CONDITION SURVEY  
OF  
**ST. TAMMANY PARISH GOVERNMENT  
BUILDING**

520 OLD SPANISH TRAIL  
SLIDELL, LA 70458

MARCH 12, 2012

**Item No. 007:**

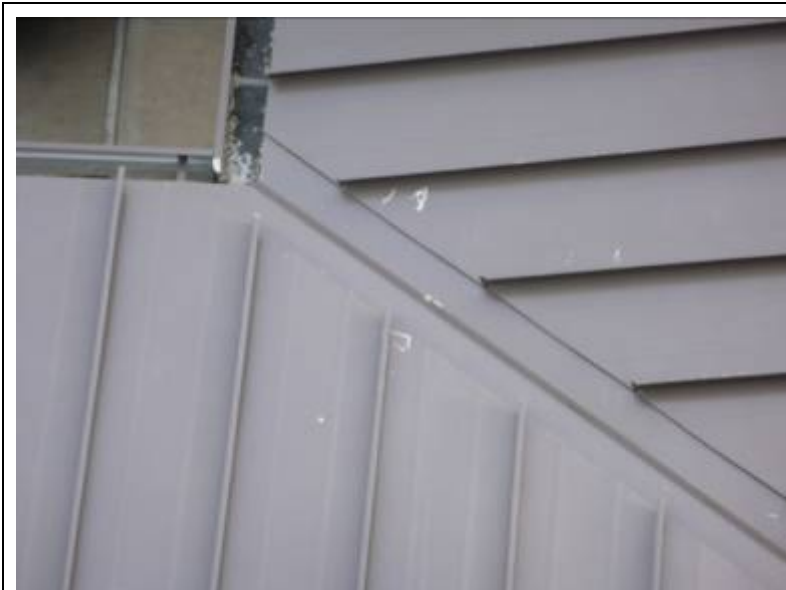
The roof panels were cut along the valley line and face attached with neoprene headed self tapping screws. The neoprene deteriorates by the UV and often leak and back out. Caulking was installed at valley lines to help stop the leaks. Caulking is a temporary repair and a maintenance issue. Caulk should not be face installed.

**Item No. 009:**

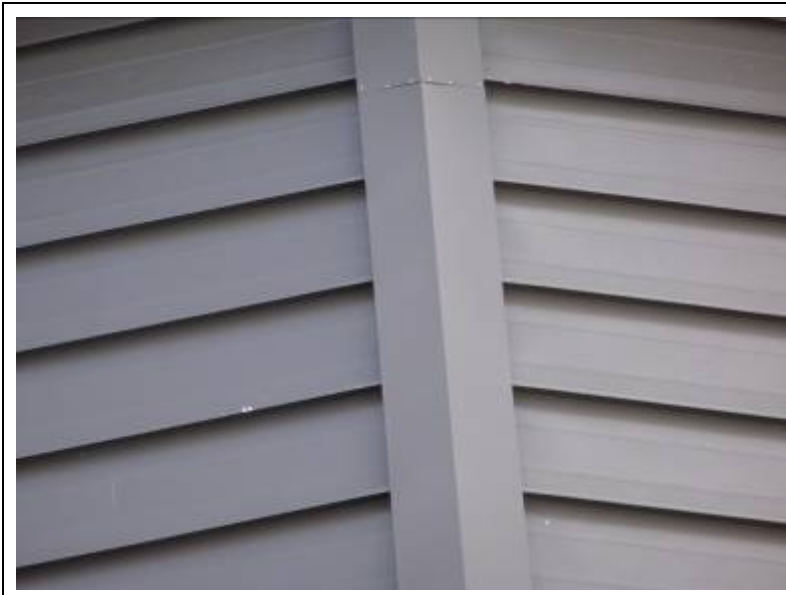
Photograph of the lower roof areas installed by another roofing contractor. Notice no face installed fasteners at the valley lines, and no caulking.

**Item No. 026:**

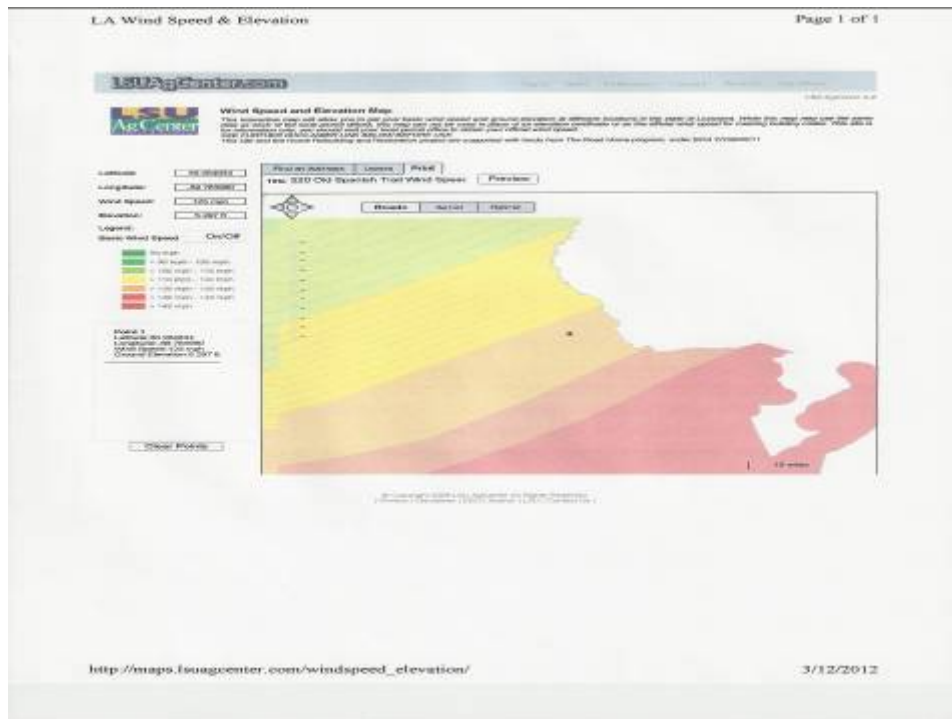
Caulking installed to stop leaks at exposed panel edges. Also shows more damage to paint finish voiding warranty.
